Company	Trenz Electronic GmbH
PCN Number	PCN-20210132
Title	TE0723-03 DDR3 Change and Product Update
Subject	BOM change
Issue Date	2021-01-29

This change affects Trenz Electronic boards TE0723 of Revision 03: TE0723-03-*

2.5 #5 Set S/N to not fitted

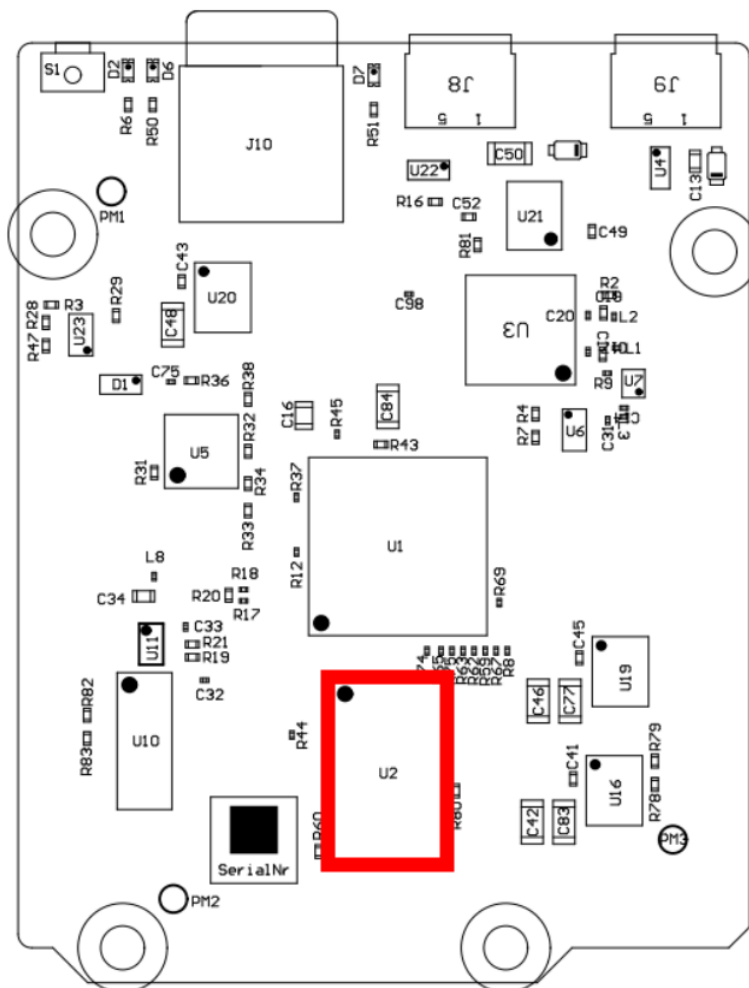
Type: BOM change

Reason: Part is end of life.

Impact: Track it pad no more available.
